CITY OF PORTLAND, OREGON - BUREAU OF DEVELOPMENT SERVICES

Building Permit # 17-251204 REV 01 FA

ATTN: Jacob Dorfler
Re: Portland Building Terracotta Tile Panel Sealant Load Testing

PORTLAND BUILDING TERRACOTTA

PLAN - TERRACOTTA TYPICAL CORNER DETAIL - TC4B

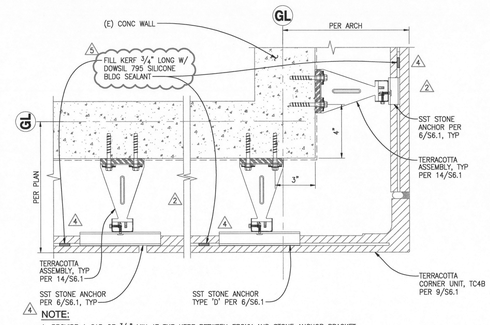
NOTE:
1. PROVIDE A GAP OF 3/4" MIN AT THE KERF BETWEEN EPOXY AND STONE ANCHOR BRACKET.

PLAN - LOGGIA OPENING AT TERRACOTTA

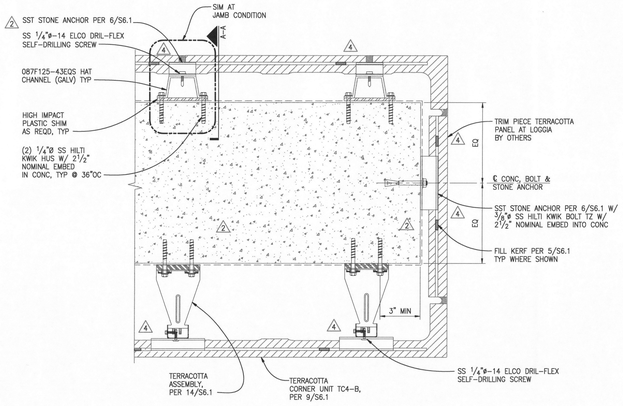
NOTE:
1. PROVIDE A GAP OF 3/4" MIN AT THE KERF BETWEEN EPOXY AND STONE ANCHOR BRACKET.

PLAN - TERRACOTTA AT METAL PANEL

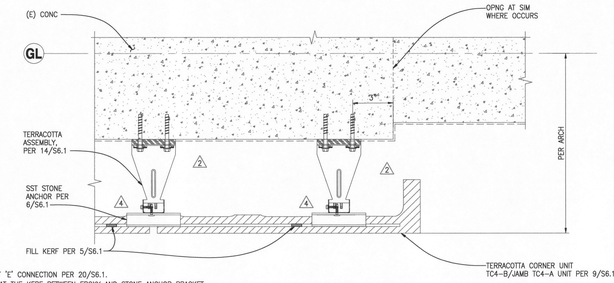
NOTE:
1. AT JAMB UNIT TC4-A AT KERF 'E' CONNECTION PER 20/S6.1.
2. PROVIDE A GAP OF 3/4" MIN AT THE KERF BETWEEN EPOXY AND STONE ANCHOR BRACKET.

PLAN - TERRACOTTA AT PIER/PILASTER

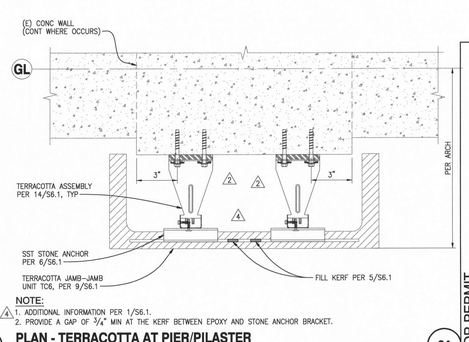
NOTE:
1. ADDITIONAL INFORMATION PER 1/S6.1.
2. PROVIDE A GAP OF 3/4" MIN AT THE KERF BETWEEN EPOXY AND STONE ANCHOR BRACKET.

PLAN - WINDOW JAMB TO TERRACOTTA (LEVEL 03) 5

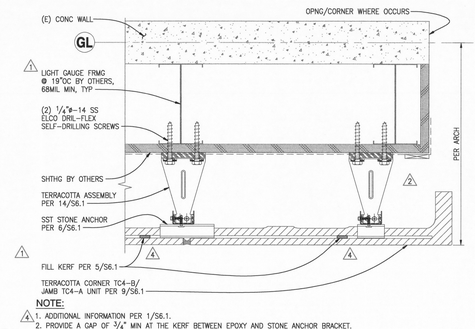
NOTE:
1. ADDITIONAL INFORMATION PER 1/S6.1.
2. PROVIDE A GAP OF 3/4" MIN AT THE KERF BETWEEN EPOXY AND STONE ANCHOR BRACKET.
